Re: Subdivision Review Application for Final United Village Development Plat by  
Snelling-Midway Redevelopment

### LOUCKS COMMENTS TO THE PRELIMINARY PLAT CONDITIONS TO BE INCORPORATED INTO THE FINAL PLAT (Red Text)

Approving the Preliminary Plat for United Village Development.

**COMMENT #3**

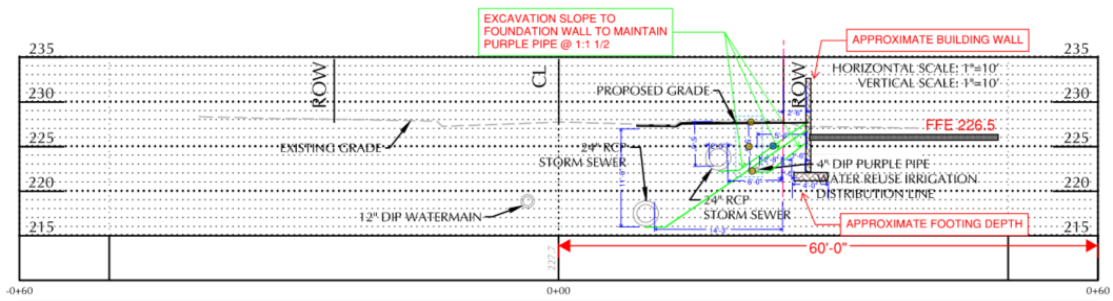
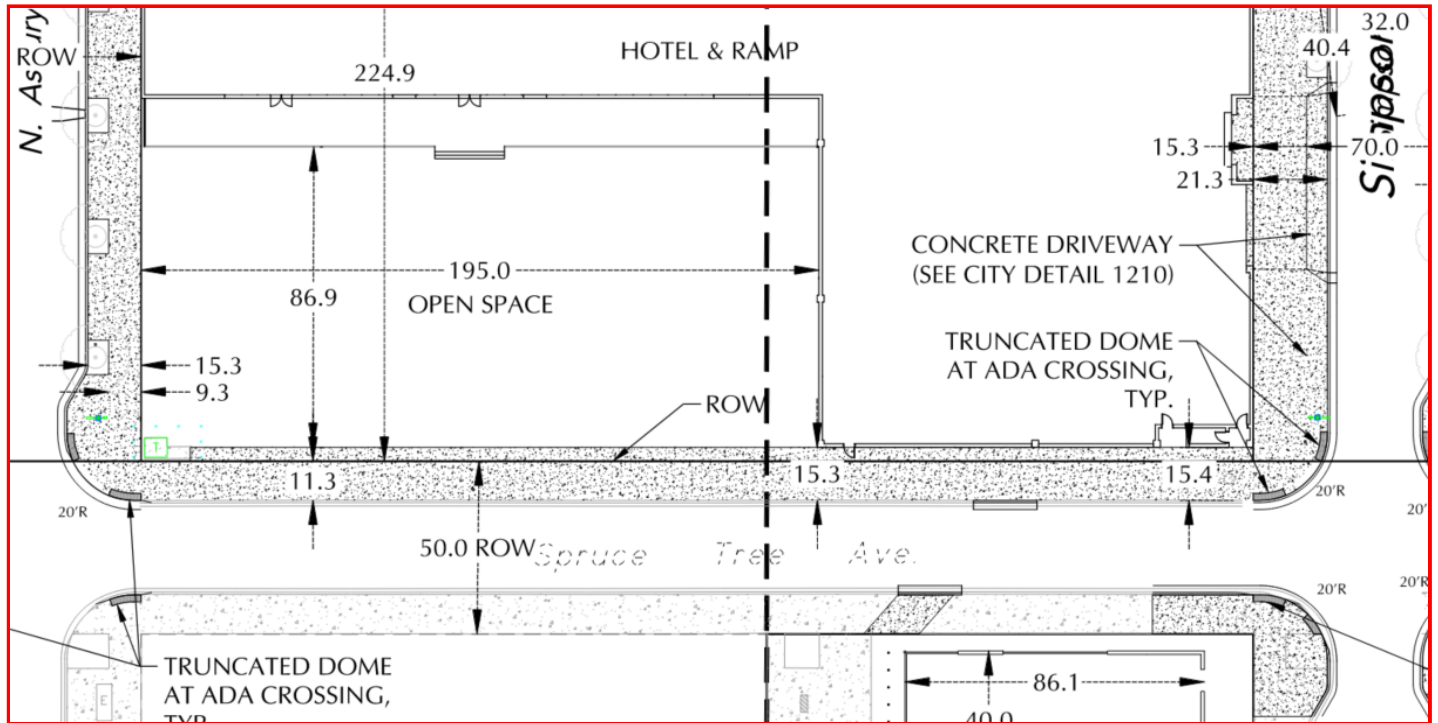
The developer must incorporate the results and recommendations of the recommendations of the Snelling-Midway Superblock Sanitary Sewer Analysis study, a sanitary sewer capacity analysis being completed for the City by consultant SEH, into the currently proposed development phase as well as all future phases and future private developments to be built on the site. **This was included in Loucks 60% Construction Plan Submittal. See Attached.**

# Midway Superblock Sanitary Sewer Calcs
